US 36 CLARIFICATION AND DETAIL FOR COMMON COMMENTS

GENERAL BIKEWAY RESPONSE

Figure 1: Lanes between McCaslin Boulevard and Foothills Parkway/Table Mesa Drive

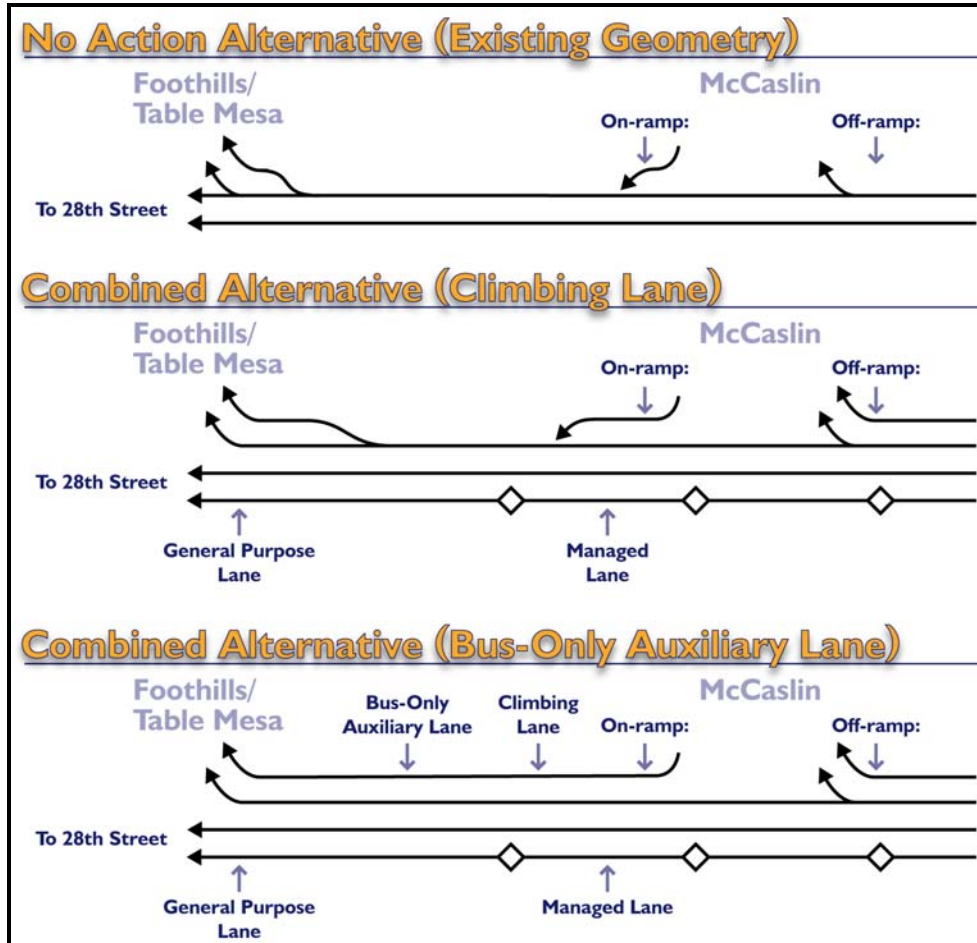
During the planning process, corridor stakeholders, including the City of Boulder and Boulder County, requested that the project team consider two variations of Package 4 that would modify the westbound auxiliary lane between McCaslin Boulevard and the Foothills Parkway/Table Mesa Drive interchange. The stakeholders were concerned that the amount of westbound capacity, provided by Package 4, would be greater than the amount of traffic the intersections in Boulder could reasonably accommodate.

In response to this request, one variation of Package 4 was developed that would shorten the auxiliary lane between McCaslin Boulevard and the Foothills Parkway/Table Mesa Drive interchange. Another variation of Package 4 was developed that would eliminate the auxiliary lane altogether. These two variations of Package 4, referred to as the “Reduce Auxiliary Lane Variation,” and the “Eliminated Auxiliary Lane Variation,” were not carried forward based on the results from the traffic impact analysis.

This issue was discussed at length as part of the PAC process to develop the Combined Alternative Package (Preferred Alternative). For the Combined Alternative Package (Preferred Alternative) agreement in July 2008, one new climbing lane in each direction, extending westbound from McCaslin Boulevard and eastbound from Foothills Parkway/Table Mesa Drive to the top of Davidson Mesa, was agreed upon for inclusion in the Combined Alternative Package (Preferred Alternative). At that time, the PAC also agreed to evaluate the extension of climbing lanes on US 36 between McCaslin Boulevard and Table Mesa Drive to bus-only lanes, as well as the use of shoulders for transit during peak travel periods.

Further traffic analysis indicated that the general-purpose lanes between McCaslin Boulevard and Foothills Parkway/Table Mesa Drive would operate at level of service (LOS) E with the climbing lane as described above. With the climbing lane extended as a general-purpose lane (westbound to Foothills Parkway/Table Mesa Drive and eastbound to McCaslin Boulevard), it was estimated that the general-purpose lanes would operate at LOS D. Therefore, the extension of the lane was determined to be a necessary element of the Combined Alternative Package (Preferred Alternative). However, only buses would be permitted to use this portion of the lanes. While the traffic analysis indicates a need for this lane by 2035, it is unclear at what point in the future the lane will become necessary. This lane is not included in Phase 1. Therefore, “triggers” for the implementation of this lane have been established and agreed upon by the PAC. The construction of this lane will not commence until approved.

Figure 1, Lanes between McCaslin Boulevard and Foothills Parkway/Table Mesa Drive, shows the existing configuration, the initial configuration with the climbing lanes, and the final configuration with the bus-only auxiliary lane, for the westbound direction.
